STAFF REPORT

TO: Planning Commission
FROM: Ashley Monterusso, City Planner
AGENDA ITEM: **Primrose Daycare Conditional Use Permit**
REVIEWED BY: Sophia Jensen, Senior City Planner
Jason Stopa, CD Director

To: Sophia Jensen, Senior City Planner
Jason Stopa, Community Development Director
Marty Powers, Public Works Director
Nate Stanley, City Engineer
Chad Isakson, Assistant City Engineer
Re: Primrose School CUP

TO: ASHLEY MONTERUSSO
FROM: SARAH EVENSON, PLA
RE: PRIMROSE DAYCARE CUP- LANDSCAPE AND TREE PRESERVATION PLAN REVIEW

SHEET NO.: G-001

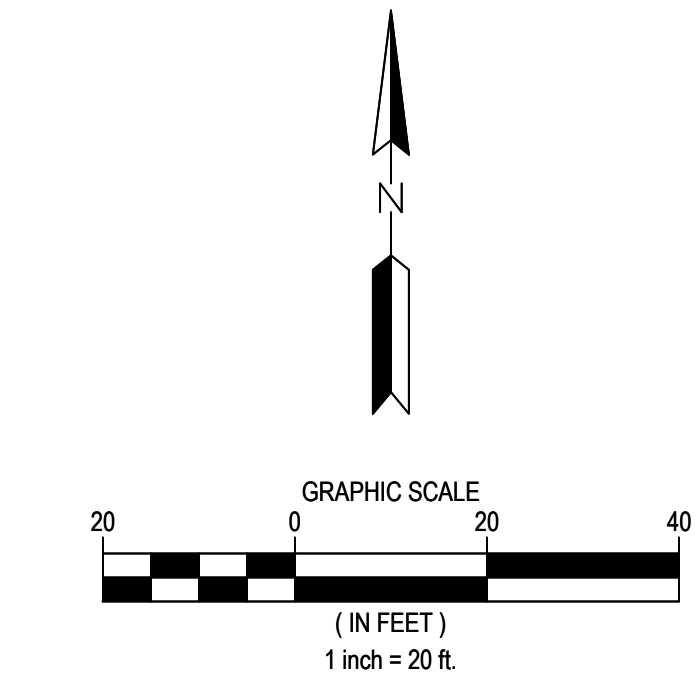
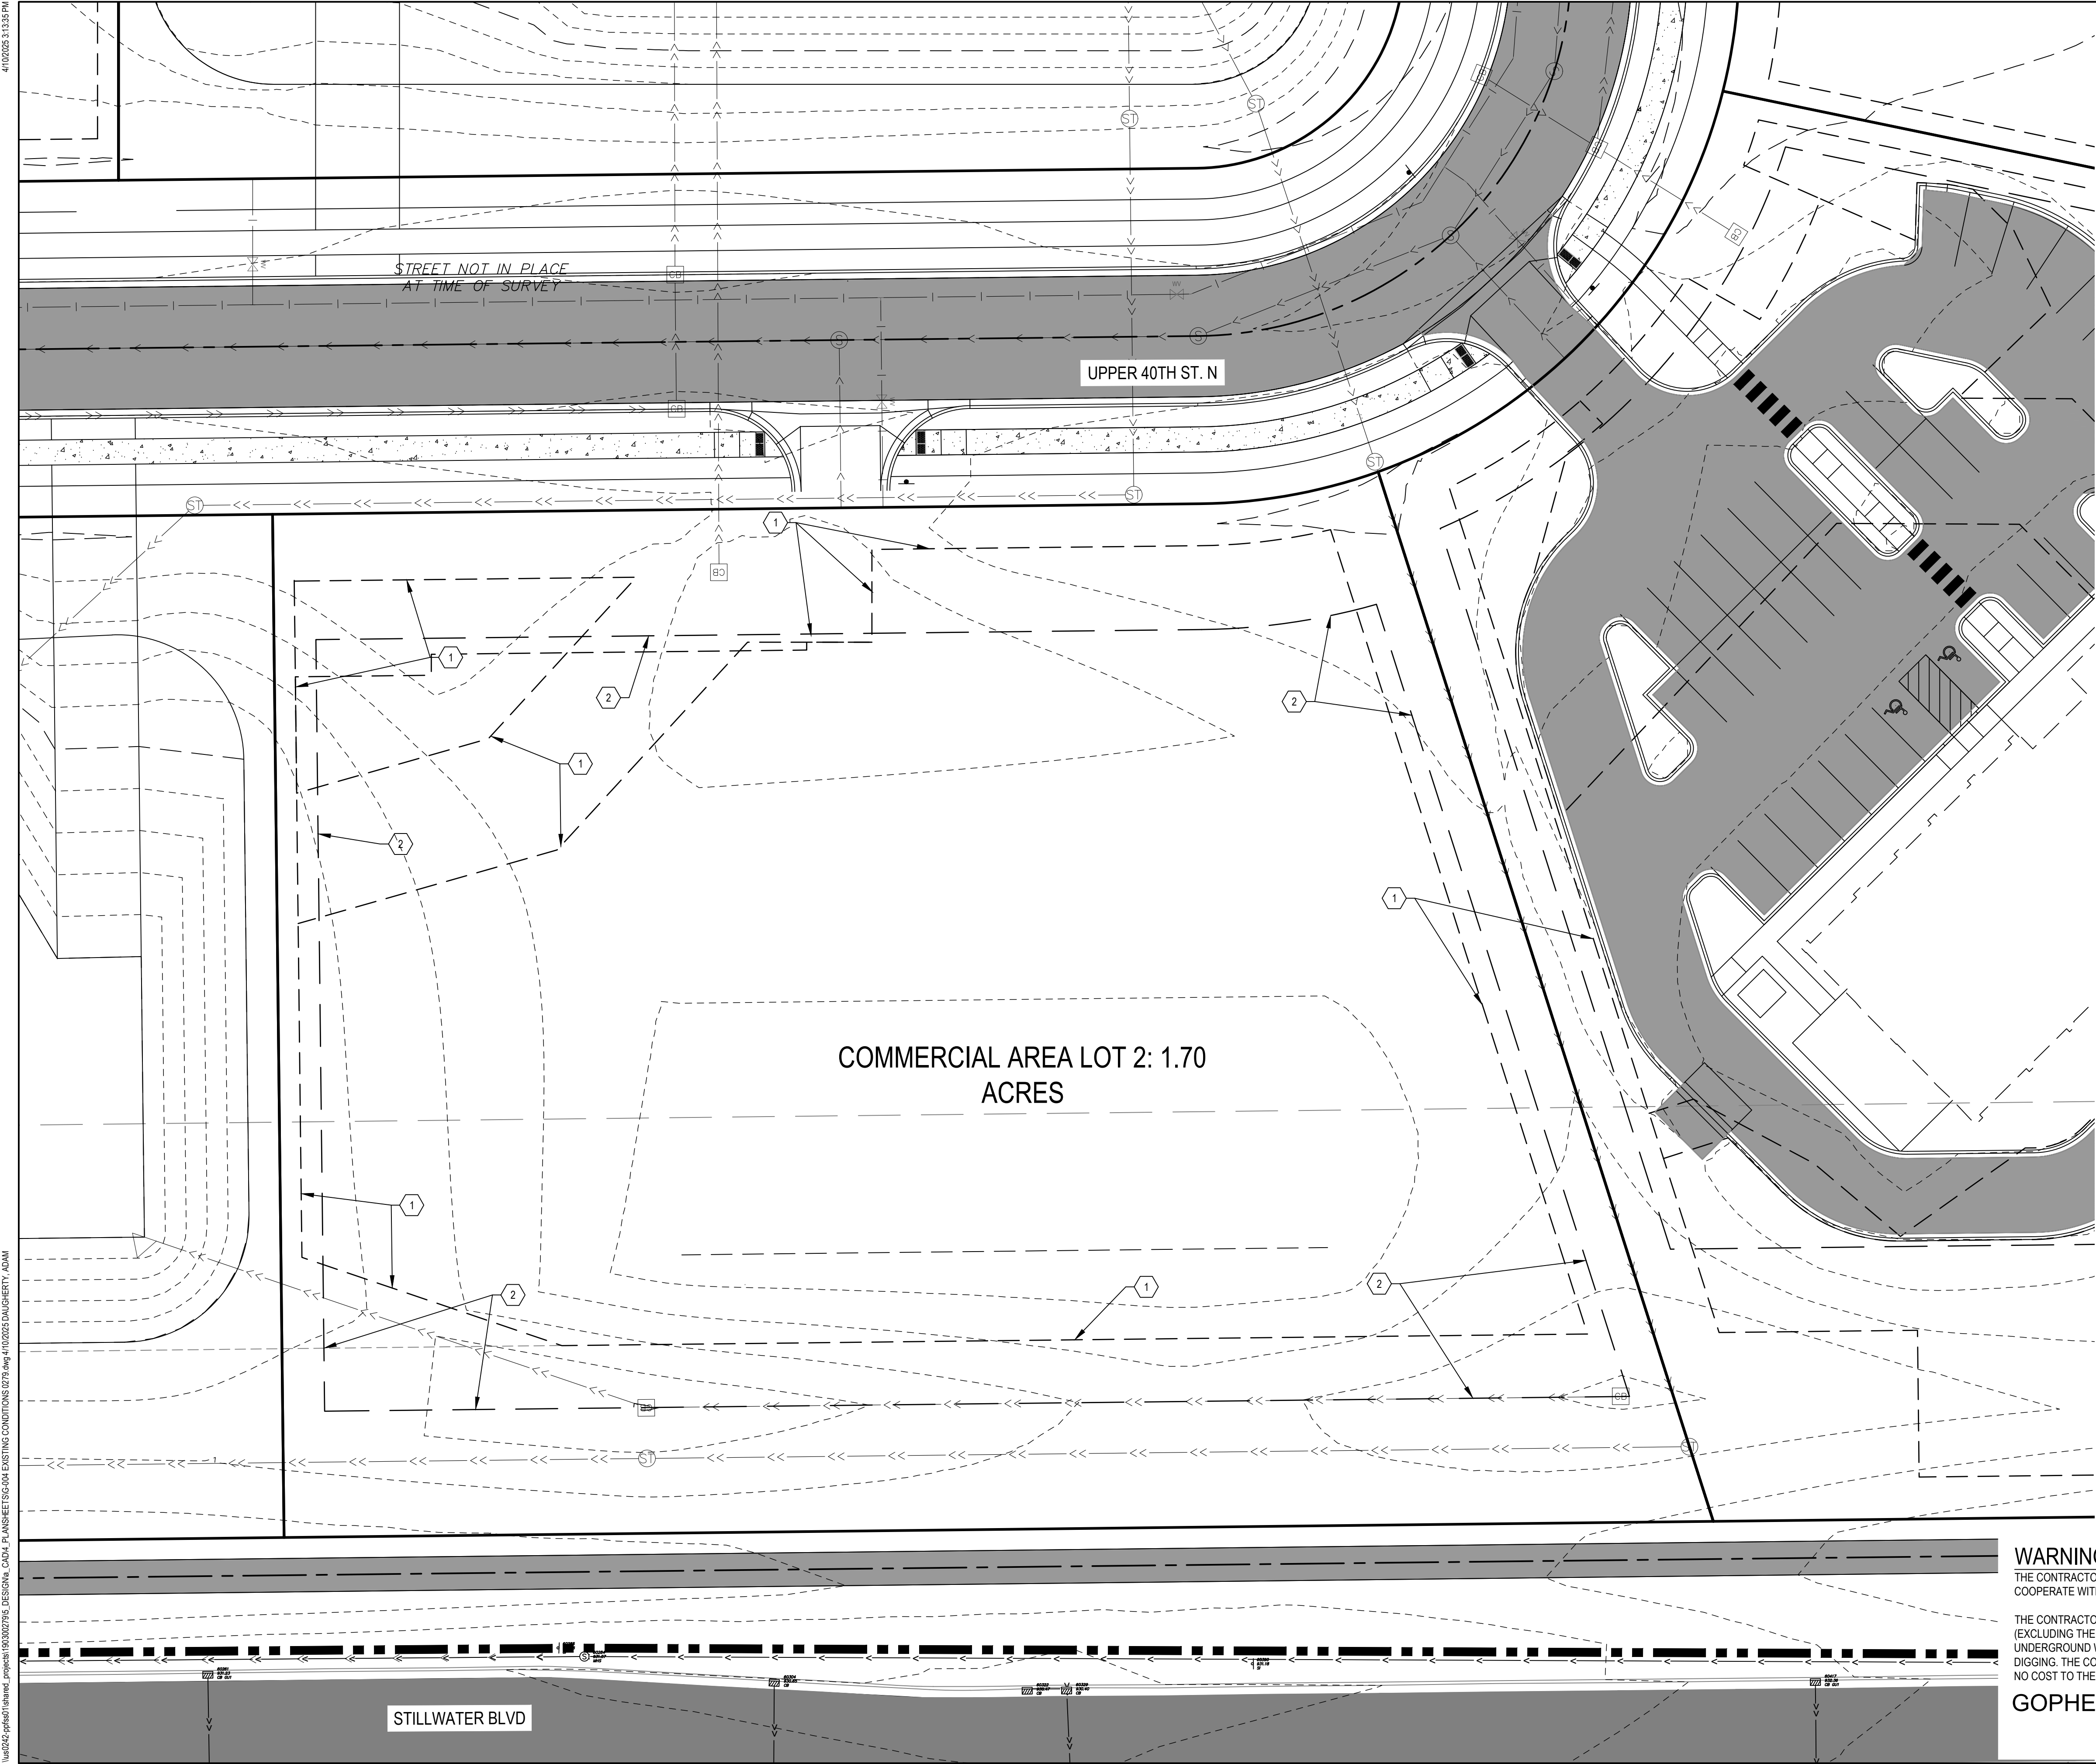
4. G-001. Add plan note to identify the standard of care guideline for the collection and depiction of existing subsurface utility data per CI/ASCE 38-02.

5. G-001. Add plan note that *"All construction parking and staging, including the loading and unloading of equipment and supplies, and including storage of materials, during the construction*

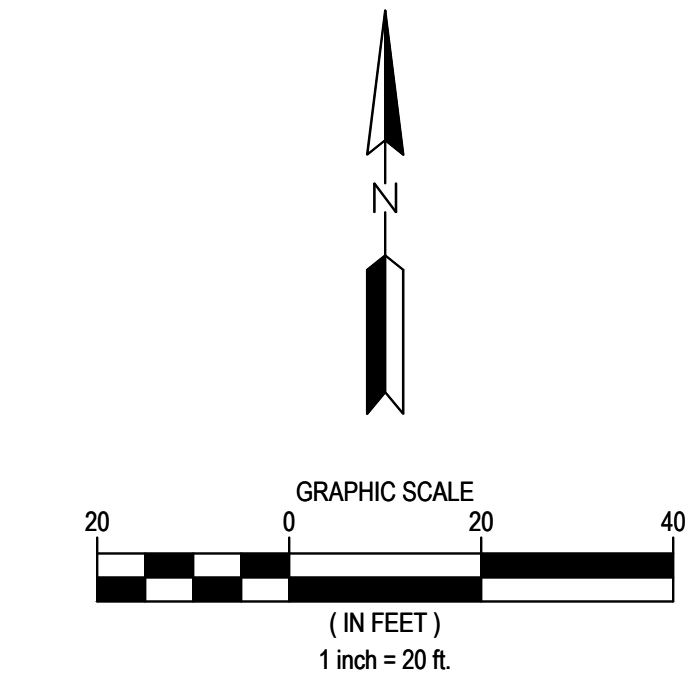
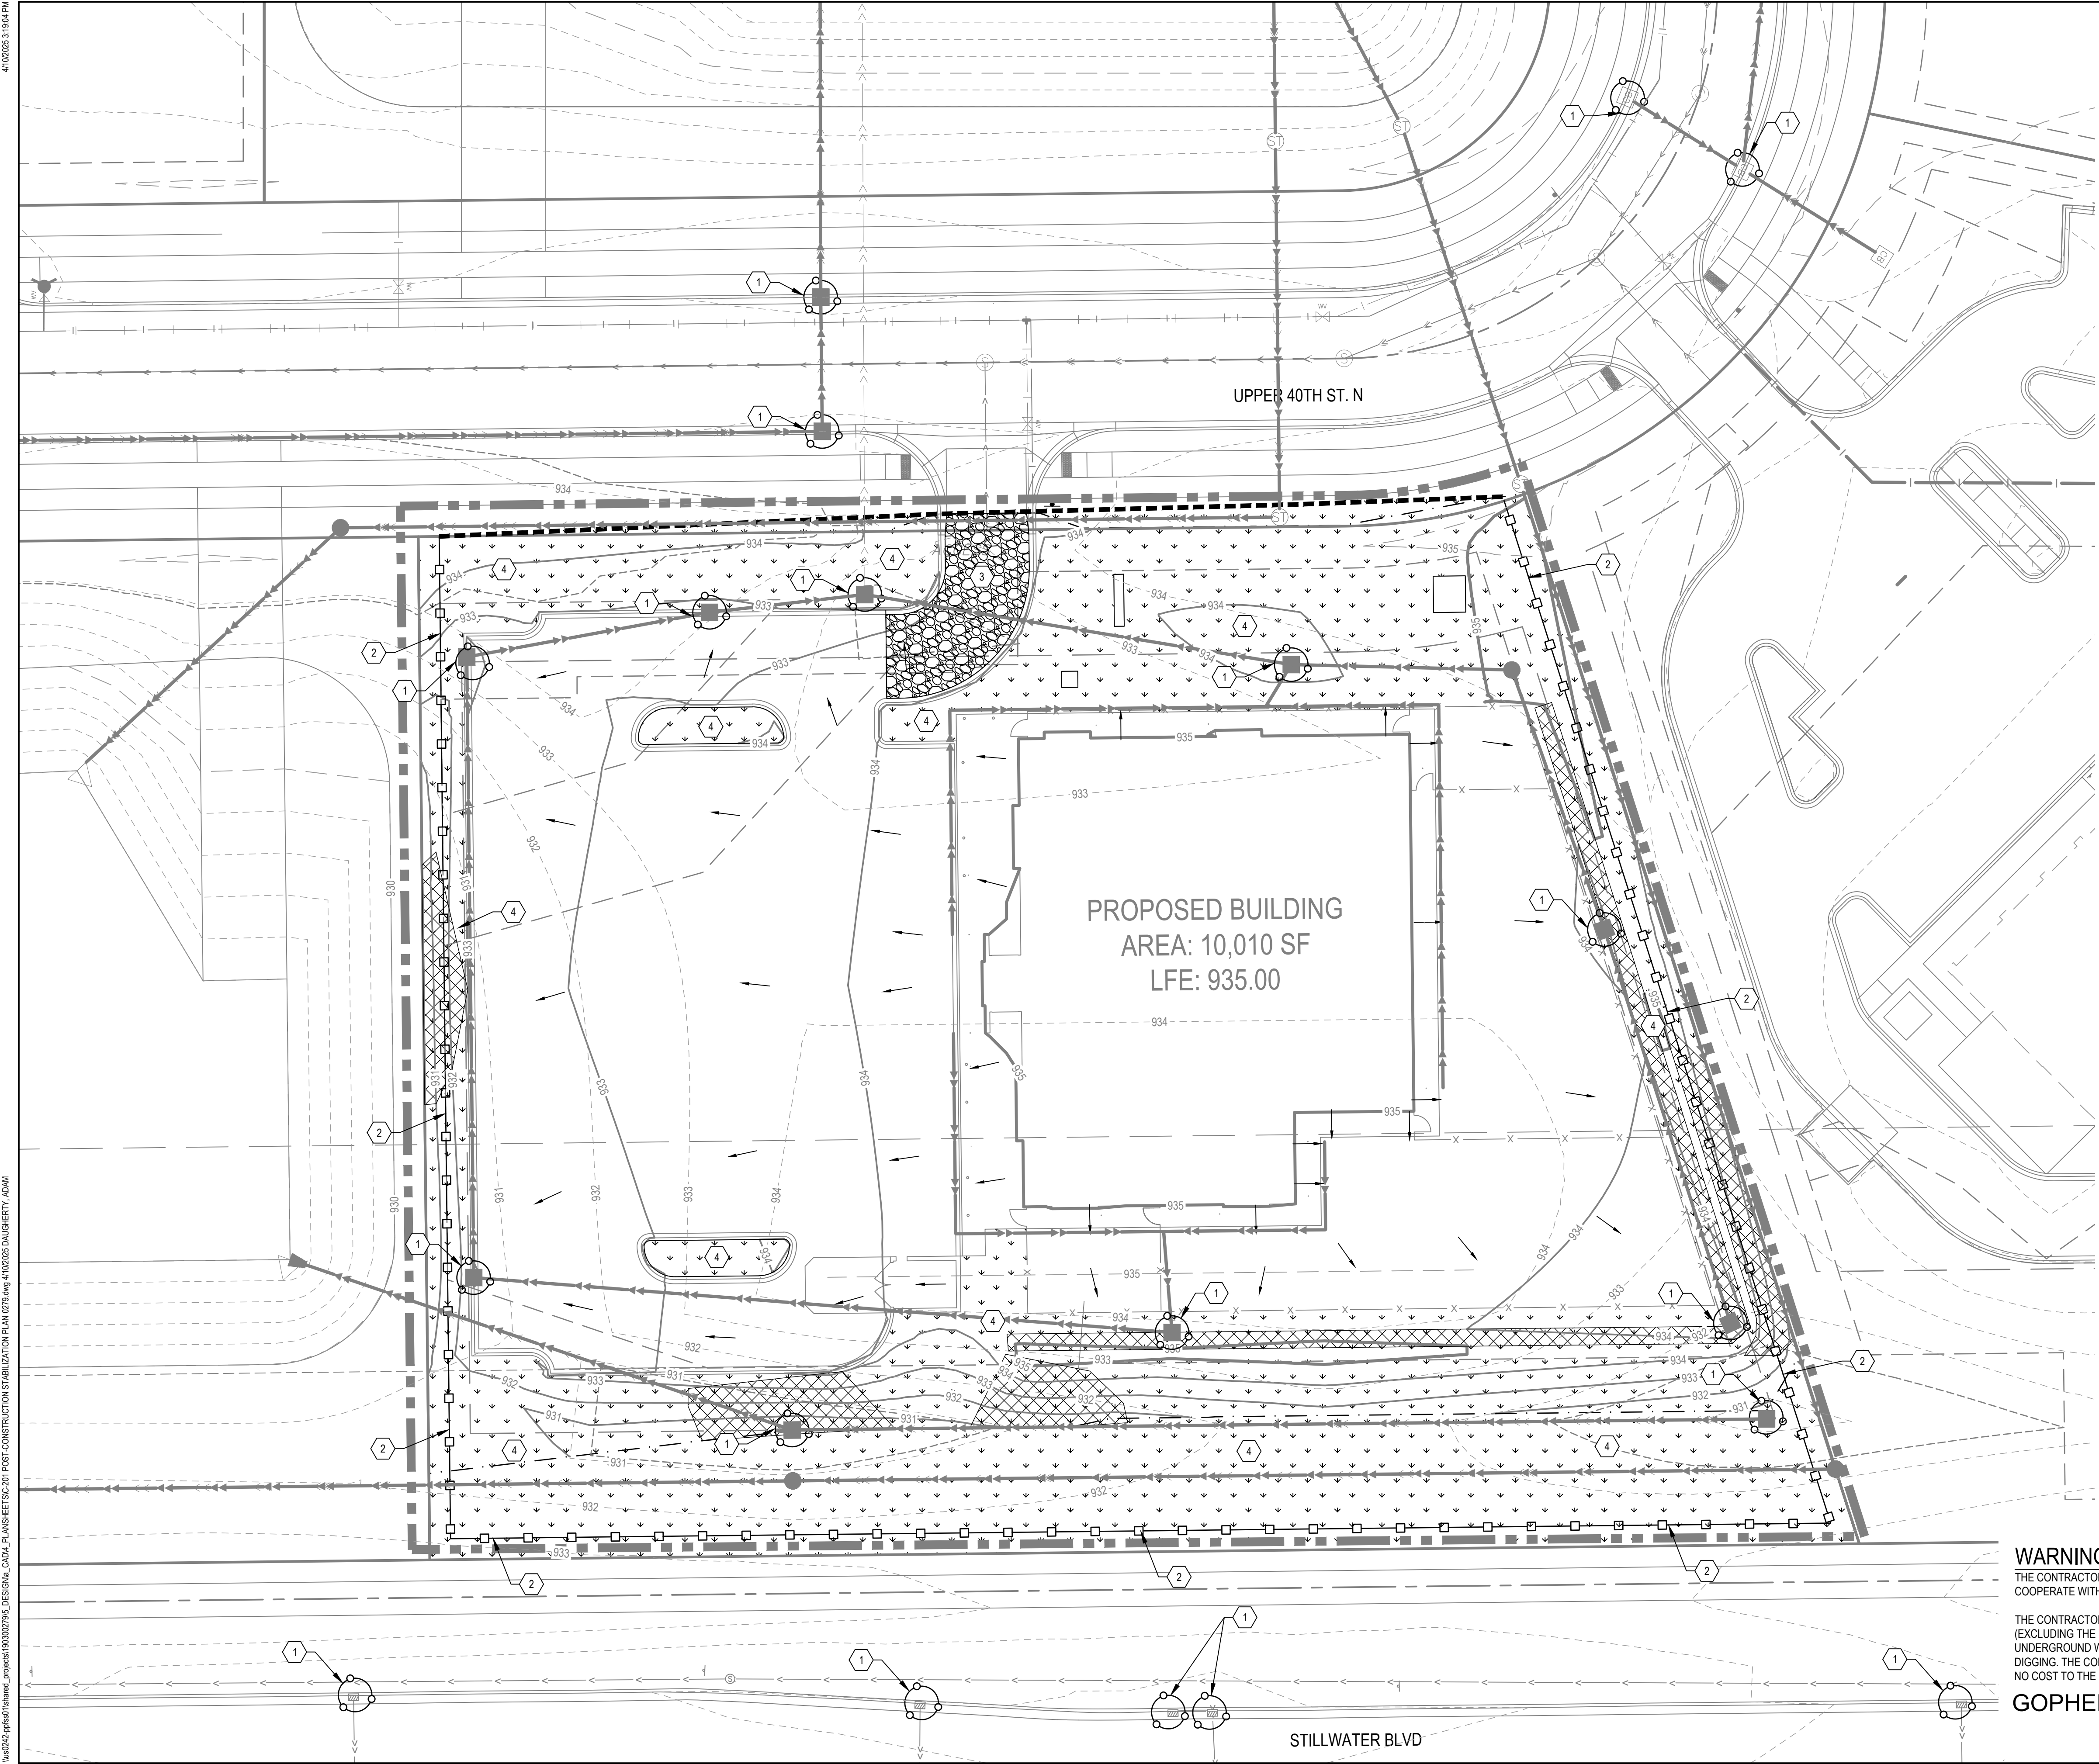
6. C-101. The commercial driveway access location is shown as approved in the Bridgewater Subdivision Improvements.
7. C-301. Site grading will be required to maintain the drainage plan as approved by the VBWD and City for the Bridgewater Subdivision Improvements, including key emergency overflow elevations and flow paths. All emergency overflow elevations must be shown and labeled on the plans.

1. Site Plan (C-101): Provide breakdown of calculations for impervious surfaces on site
2. Photometric Plan: t@22.5 fixture on West side of property doesn't meet code, 105.04.070 as footcandle is over .4 from property line, please revise
3. Trash Enclosure: materials used for trash enclosure screening need to be submitted for review
4. Signage: Please note there is a separate review process for wall and monument signs. [105.12.430 Sign Regulations](#)
5. Fencing: Please note there is a separate review process for fencing. [105.12.400 Fencing Regulations](#)
